TAKAMIYA SEAWALL *REPAIRS* 2-8-94
Final
ENVIRONMENTAL ASSESSMENT
SEA WALL AND DRAINAGE SYSTEM
AT 98-165 AIEA KAI WAY
KALAUAO, 'EWA, O'AHU

TMK: 9-8-15: 57

SUBJECT: ENVIRONMENTAL ASSESSMENT (EA)
TAKAMIYA SEAWALL MODIFICATION AND NEW DRAINAGE SYSTEM
TMK: 9-08-15: 57

Subject: Draft Environmental Assessment (DEA) for Sea Wall and
Drainage System Construction At 98-165 Aiea Kai Way
Kalaauao, Ewa, Oahu
TMK: 9-8-15:57, Lot 6

Figure 6. Engineering drawings of the proposed sump pit.

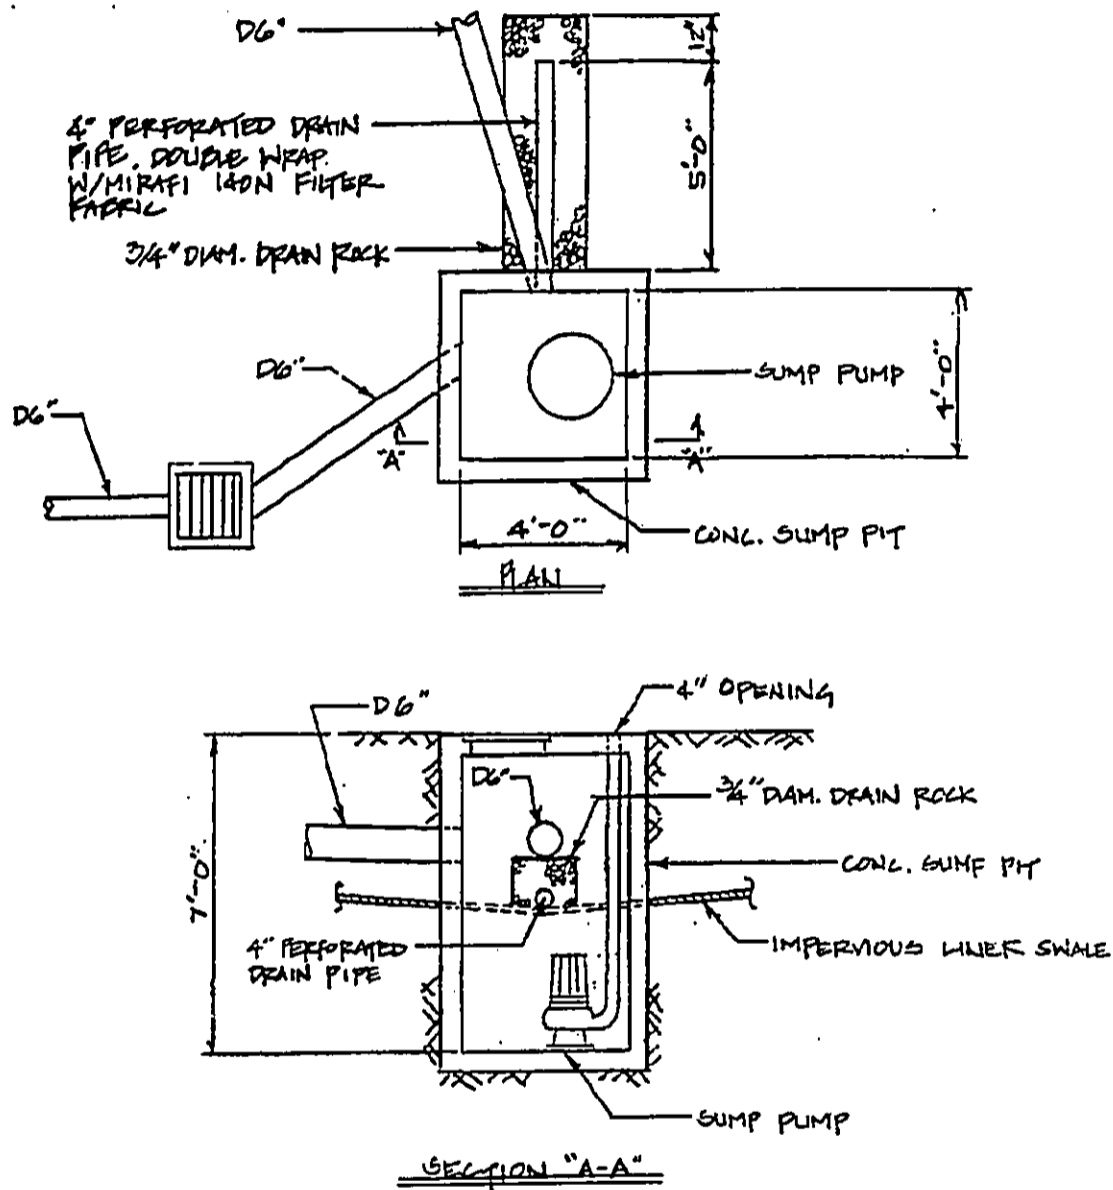
- ✓ a. Construction of a sump pit;
 - b. Excavation of the trench or installation of a 6" drainage pipe; and
 - c. The installation of the impervious liner swale.

2. We recommend that the drainage system be constructed in such a manner that:
 - ✓ a. Storm water runoff will be collected by gravity flow;
 - b. Proper filtration or screening devices be installed to prevent solid waste, leaves or other pollutants from being washed into the sump pit; and

- c. The sump pit should be so designed as to allow only the overflow to be discharged into Pearl Harbor.
3. An NPDES permit is required if the final design requires the operation of a pump to discharge the collected runoff into Pearl Harbor.

1. We have notified the client and the design engineers that a dewatering permit under the State's NPDES General Permits program may be required for the construction of the sump and possibly other trenching activities as proposed.
2. We will pass along your recommendations for minimizing adverse water quality impacts to the design engineers.
3. We have submitted an NPDES permit application to DOH as suggested in your letter and in discussion with your staff.
4. The draft EA stated that no part of the drainage system would be built on State land (p. 5). So long as the end of the discharge pipe does not extend seaward of the outer face of the sea wall, no additional State or Federal permits are required for the construction as described.
